**Re: Traffic Addendum Letter
Proposed Residential Subdivision
63 and 63A Trafalgar Road (Wellington Road 24),
Town of Erin, County of Wellington
File Number: 23T-23003, OP23-01, Z23-02**

On behalf of Beachcroft Investments Inc., CGE Consulting hereby acknowledges the comments received from the Town and peer reviewers concerning our first Transportation Study submission.

DRAFT PLAN OF SUBDIVISION

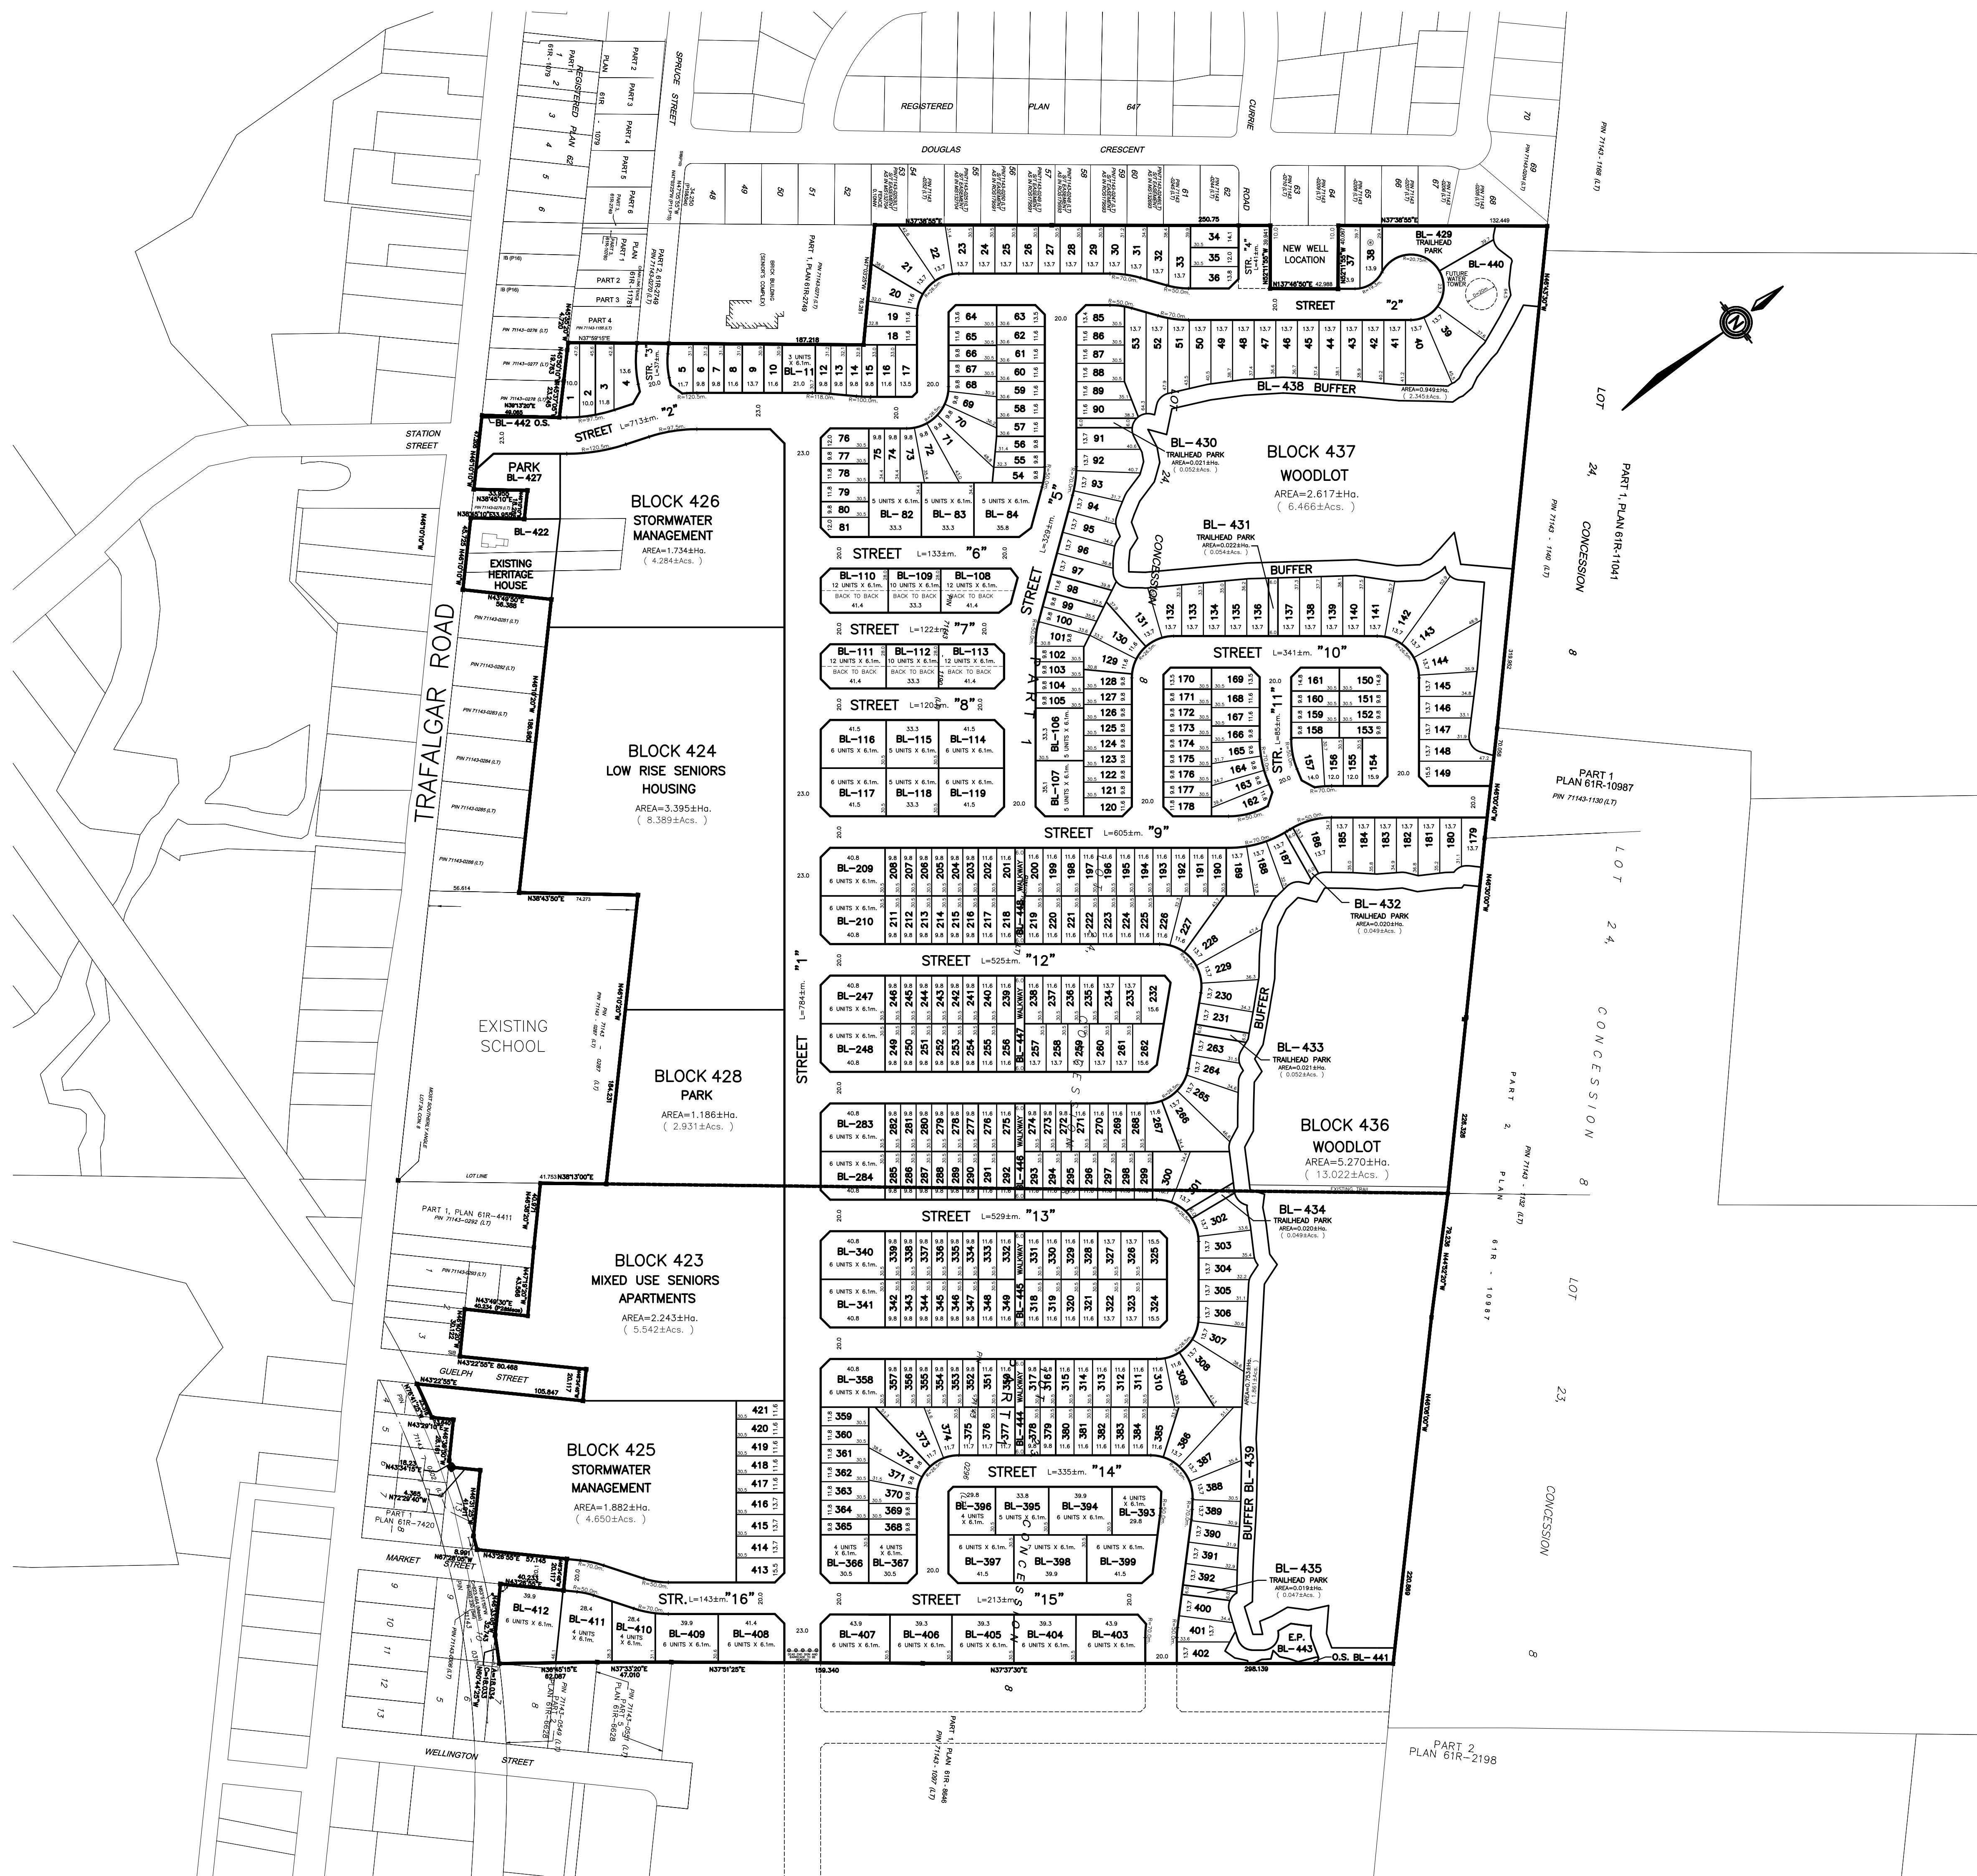
Comment 29: A review of a student drop-off zone on Street 9 be provided as part of the detailed design.

Comment 31: Details regarding the feasibility of the pedestrian connections through Open Space Blocks 523 and 524, including preliminary grading, are to be included prior to Draft Plan Approval.

Response: Street “9” is now shown in the updated draft plan of subdivision as no longer extending to the school, reflecting a change in the layout.

Response: The latest revision of the subdivision plan excludes Open Space Blocks 523 and 524. A high-level preliminary and desktop analysis of the updated layout suggests that Open Space Blocks 441 and 442 do not appear to be impacted by grading issues, indicating their suitability for pedestrian connections. Detailed confirmation and additional information about pedestrian pathways will be provided in the forthcoming internal function design study.
